SUBJECT: Forwards review of geologic & seismologic data submitted by Southern CA Edison Co in support of position re San Onofre Units 1 & 2.

Review of Geologic and Seismologic Data Relative to the
San Onofre Units 2 and 3 Operating License Application

ADDENDUM TO:
REVIEW OF OFFSHORE SEISMIC REFLECTION PROFILES IN
THE VICINITY OF THE CRISTIANITOS FAULT,
SAN ONOFRE, CALIFORNIA

Figure 361.45 - 1 Empirical Plot
Geologic Slip Rate VS Historical
Magnitude for Strike-Slip Faults

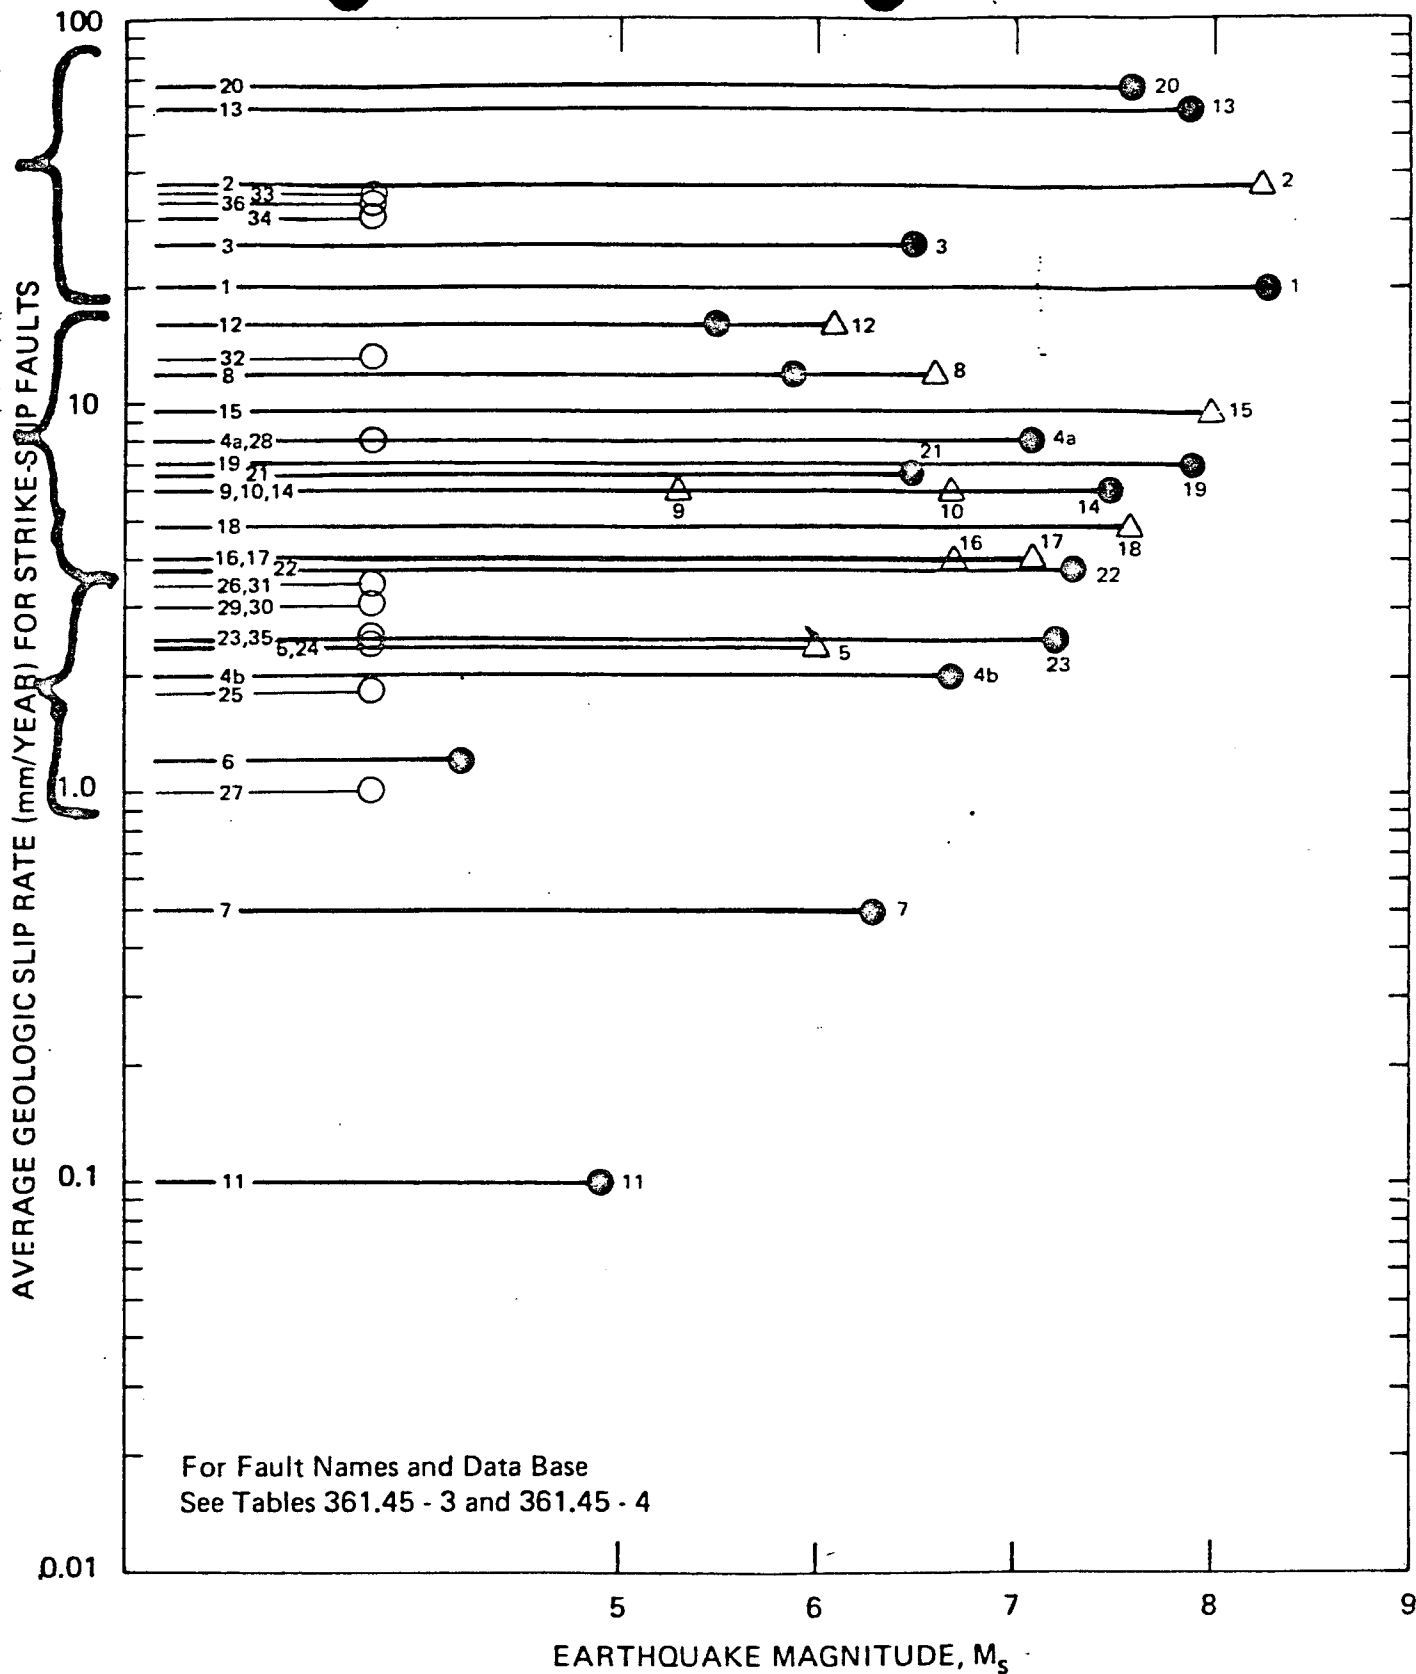
On the question of the statistical significance of the slope of a line bounding points on the log slip-rate versus magnitude plot, the applicant's consultants point out that while a single fault with low slip-rate is unlikely to have a "maximum" earthquake in historic time, a group of low-slip-rate faults has a significance proportional to their moment-rate sum. This same reasoning can be applied quantitatively.

There are 14 faults in Group 2 (see attached figure) with slip-rates ranging from 3.5 to 17.5 mm/yr. Seven of these faults have had historic earthquakes within one magnitude unit of the proposed "maximum earthquake limit" (MEL) line, and two have had earthquakes within 1/2 magnitude unit of the proposed MEL line.

There are 11 faults in Group 3 with slip-rate of 0.7 to 3.5 mm/yr. It is stated on p. 361.51-2 of the SCE report of February 1980 that "The total moment rate for group 3 is roughly equal to the average rate for group 2." Therefore, the faults of group 3 collectively have the statistical weight of a single fault of group 2. The probability that any earthquake in group 3 is within one magnitude unit of a properly-drawn "maximum earthquake limit" line is $7/14 = 0.5$, and the probability that any earthquake on any fault in group 3 is within 1/2 magnitude unit of the MEL is $2/14 = 0.14$. Therefore, there is a substantial probability that the MEL line should be steeper than shown in Figure 361.45-4, and earthquake magnitudes at smaller geologic slip-rates could be larger. During discussion the applicant made the observation that there are probably many faults with small geologic slip-rates and no historic earthquakes which are not shown on the plot and that these should be included in an estimate of statistical significance. It remains to be shown that the number of such faults increases inversely with decreasing geologic slip-rate. Consequently, an empirical technique based on such limited data cannot be considered definitive in assessing maximum magnitude. However, this technique is helpful, when considered along with other procedures for estimating earthquake size to assess the potential impact of earthquakes on the SONGS site.
